TOWNSHIP OF FRANKLIN
Board of Adjustment
Agenda
Thursday, June 18, 2026

UKRAINIAN ORTHODOX CHURCH OF U.S.A / ZBA-25-00008

RE: ***Ukrainian Orthodox Church of U.S.A.
Parking Lot Improvements
Preliminary & Final Major Site Plan
Report #3
Engineering
Block 469, Proposed Lot 1.09
135 Davidson Avenue
Franklin, New Jersey
Our File: MFRZ0469.03/600.01
Application # ZBA-25-00007***

Figure 2: FEMA Special Flood Hazard Area along stream and in roadway

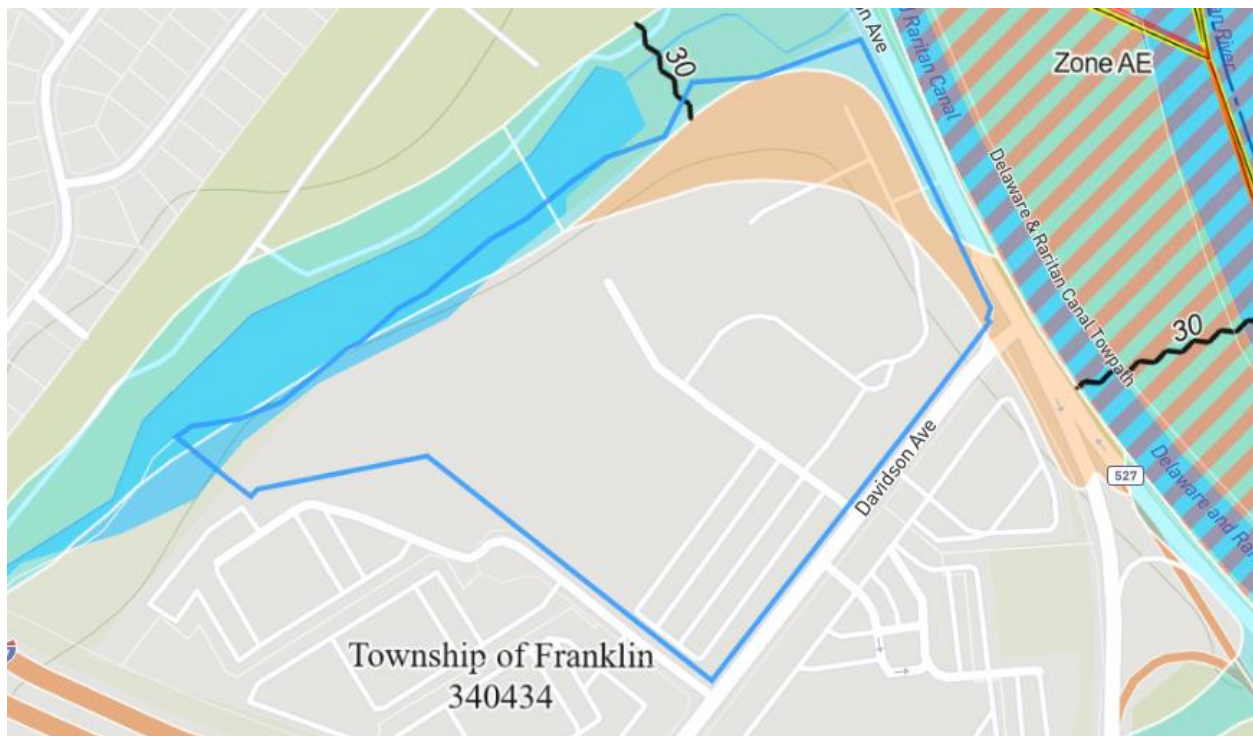
- FEMA records show a Special Flood Hazard Area on a portion of the property.
- GIS information provided by the NJDEP indicates that wetland areas may exist on a portion of the property.
- The applicant is proposing to subdivide the property into two lots, fully conforming in size and all bulk requirement for the zone. A variance is required for expansion of a non-conforming use; the church and cultural center are preexisting non-conforming uses in the B-I Zone.
- It is presumed that the applicant is proposing to perfect the minor subdivision by deed filing with the County.

Figure 5: Proposed Subdivision (ZBA-25-00008)

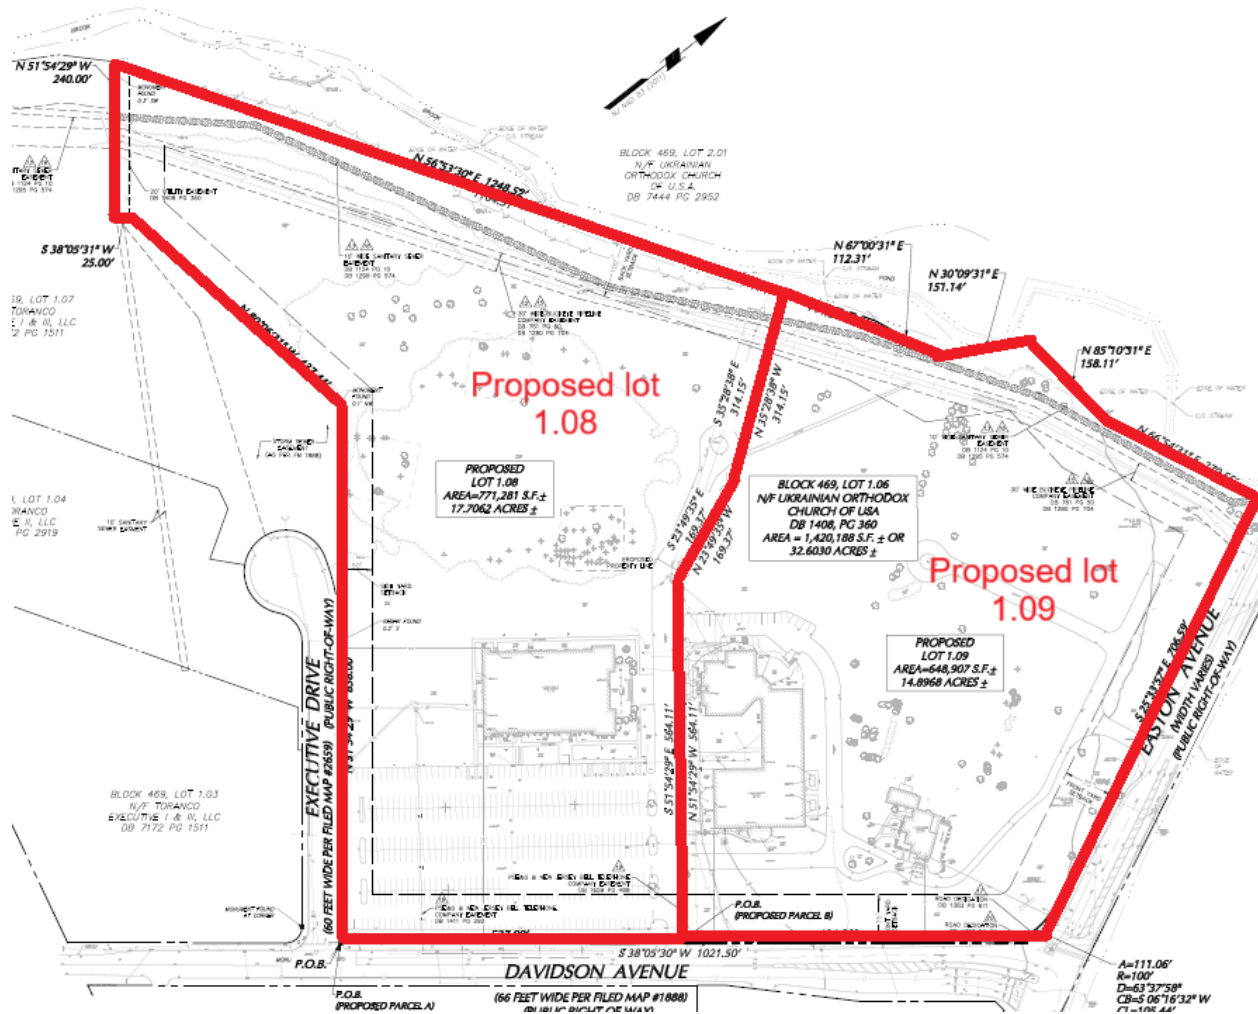
1. The applicant is proposing to subdivide the existing lot into two new parcels. Should the Board act favorably, the new lots shall be as follows:
 - Plan Lot 1.08 = New Lot 1.09
 - Plan Lot 1.09 = New Lot 1.08

3. Minor Subdivision Plan:
 - Update the proposed lot numbers in accordance with Comment #1
 - A concrete monument shall be set at the intersection of the external boundary line with the right-of-way of Easton Avenue. A monument already exists at the boundary line intersection with Davidson Avenue.
